Re: ACP Ref. 324277 – Response to Observations on Substitute Consent Application at Ardcahan, Dunmanway, Co. Cork

RE: ARDCAHAN QUARRY - CORK COUNTY COUNCIL REPORT RESPONSE LETTER

Appendix F – Viridus Response Letter, including Water Framework Directive Assessment

Scaled Map Identifying Each of the Nearest Noise Sensitive Receptors at Distances Of 500m& 1km From the Nearest Development Boundary in Each Direction

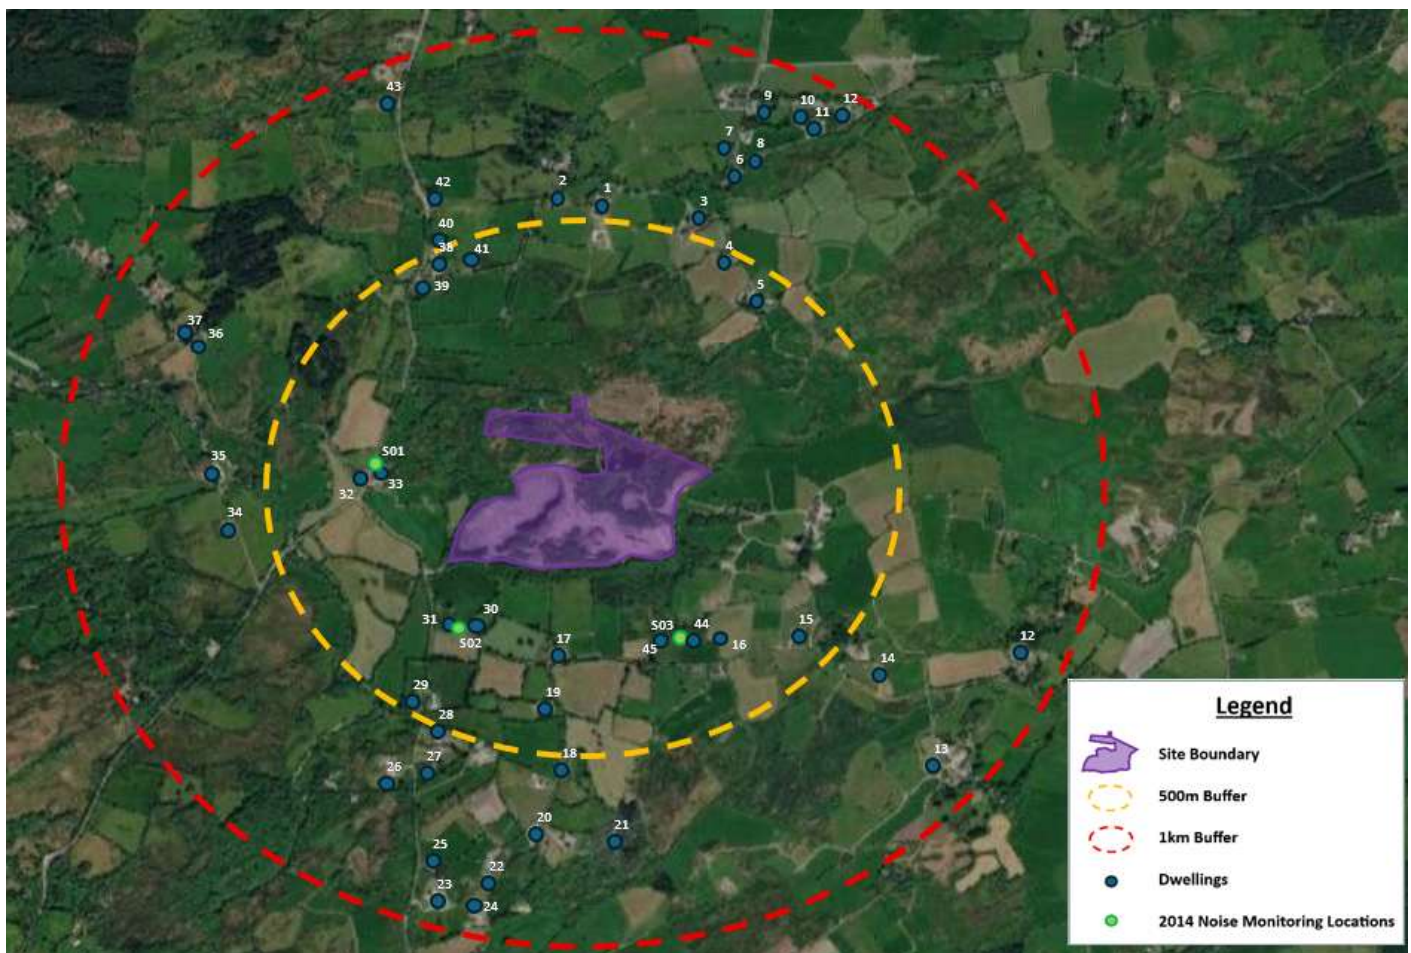
1.) The respective number and distances of all noise sensitive receptors within 500m and 1000m of the proposed development should be presented and quantified. The referenced noise sensitive receptors that each selected noise monitoring location is considered to be representative of should also be identified and quantified and shown on a suitably scaled map.

A scaled map identifying each of the nearest noise sensitive receptors within 500m and 1km of the substitute consent application is provided in Appendix A at the rear of this document. The map also includes the 2014 noise monitoring locations (S01, 02 & 03).

Figure 1: Hydrological Features including the local catchment area of the adjacent 'Boundary Stream'.

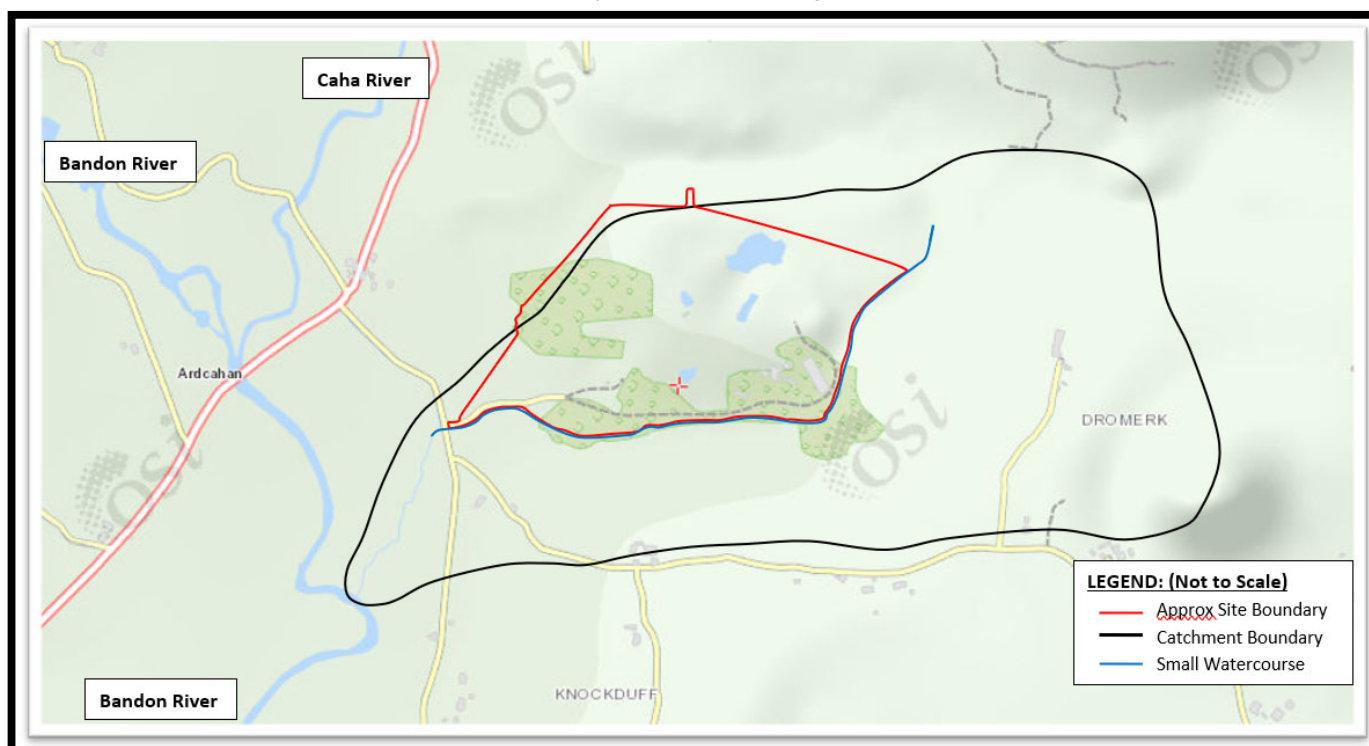
As per your recent request, in response to the Cork Co. Council (CCC) report to An Comisiún Pleanála, (ACP), on the Ardcahan Quarry Substitute Consent Application by Murray Brothers Tarmacadam Ltd., (MBT), for the historic quarrying of sandstone bedrock that took place between Feb 1990 and Oct 2014, (along with associated site development works), at Ardcahan, near Dunmanway in Co. Cork, VCL have reviewed Chapter 7 (Hydrology and Hydrogeology) of the remedial Environmental Impact Assessment Report (rEIAR) with a view to reporting the aspects specifically pertaining to the requirements of the Water Framework Directive (WFD), and present that information below.

The stream flows adjacent to the site close to its eastern and southern boundaries and reaches the Bandon River about 500m to the southwest of the quarry site. Refer to Figure 1.
